FILE: CSSTP-0007-00(414) Camden **OFFICE:** Engineering Services
P.I. No.: 0007414
Colerain Road Widening and Reconstruction **DATE:** September 29, 2009

SUBJECT: IMPLEMENTATION OF VALUE ENGINEERING STUDY ALTERNATIVES

FILE: CSSTP-0007-00(414) Camden County
P.I. No. 0007414
Widening Colerain Road
from I-95 to Kings Bay Road

SUBJECT: Value Engineering Study-Responses

TRIPLE X-DRAIN @ COLERAIN RD STA 218+75

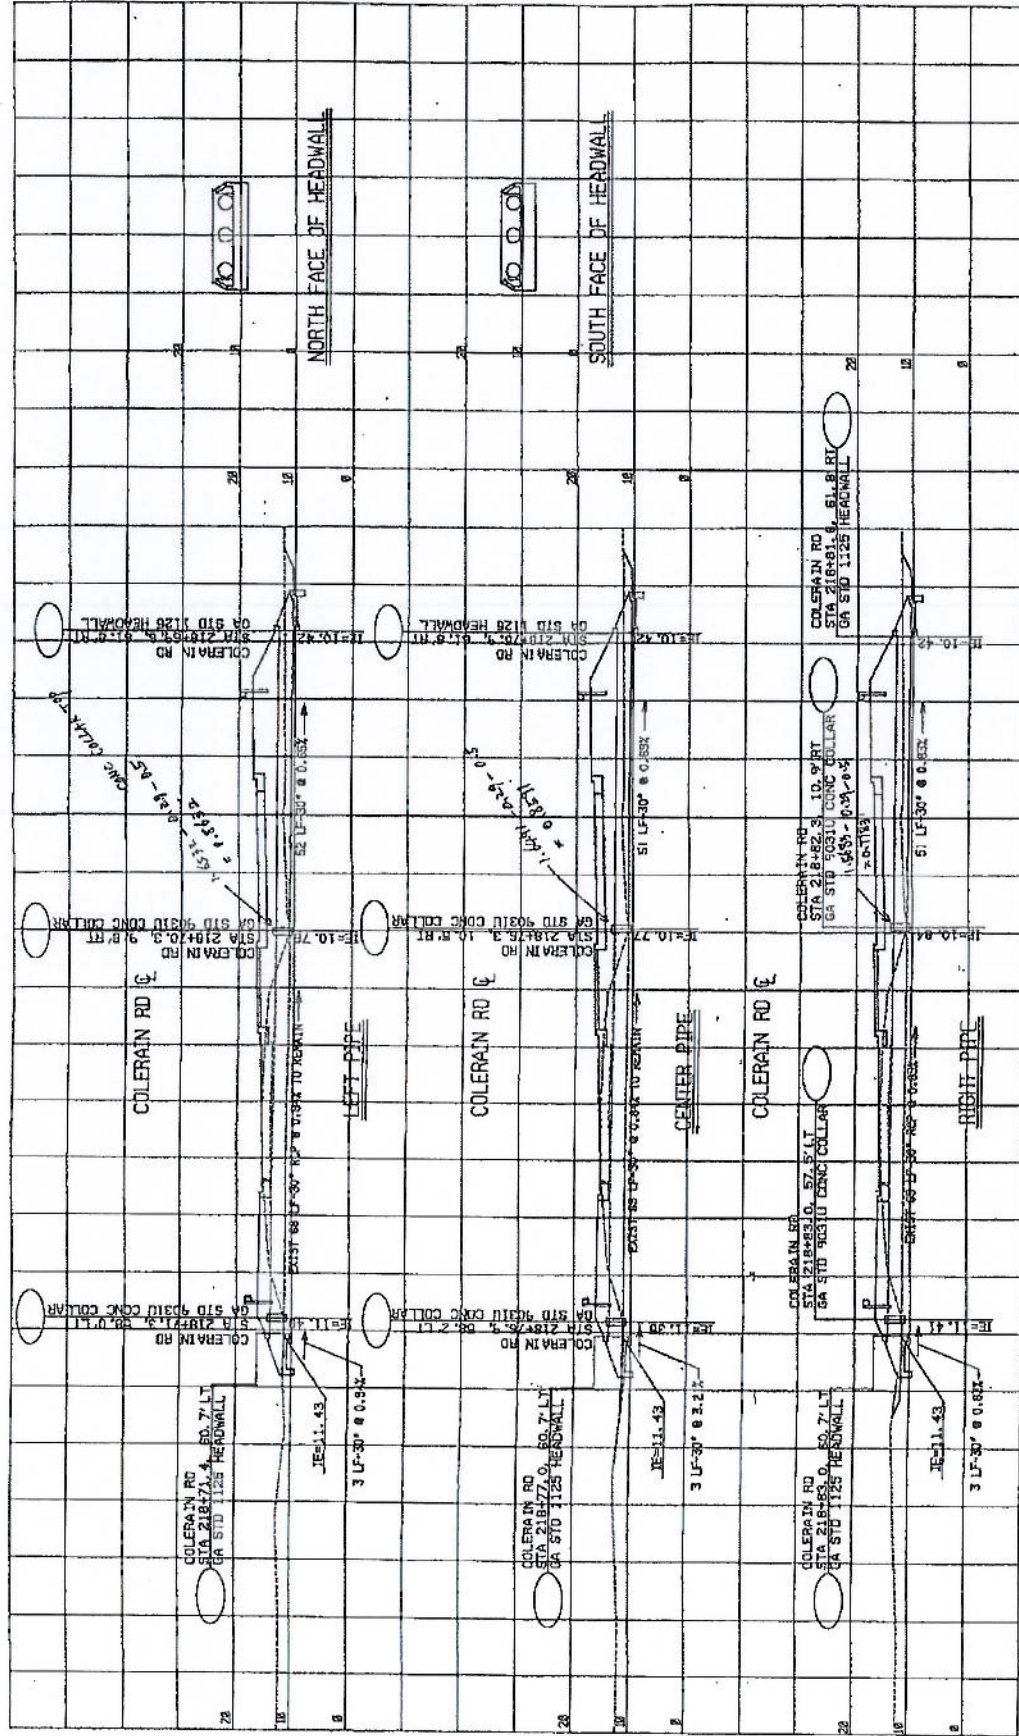
1. Value Engineering Design Suggestion DR-1 – Eliminate the reverse crown.

- *The proposed widening typical section uses a reverse crown to achieve minimum cover over the extended cross drainpipes. It is recommended to retain the proposed reverse crown section at the triple 30" cross drain at Sta 218+75 which is located on a 1490.33-foot horizontal tangent between two horizontal curves that are superelevated in the same direction as the reverse crown tangent. See Attachment "A" for the proposed roadway section at the cross drainpipe location. It is recommended that the proposed reverse crown roadway section between Sta 109+40 to Sta 116+40 left and Sta 123+20 to Sta 130+30 left be revised to a normal crown roadway section. The proposed profile would be raised to achieve minimum pipe cover for the triple 36" cross drain at Sta 113+20 and the triple 30" cross drain at Sta 126+75. No initial cost savings was associated with the design suggestion.*

A variation of the VE Design Suggestion DR-1 is recommended.
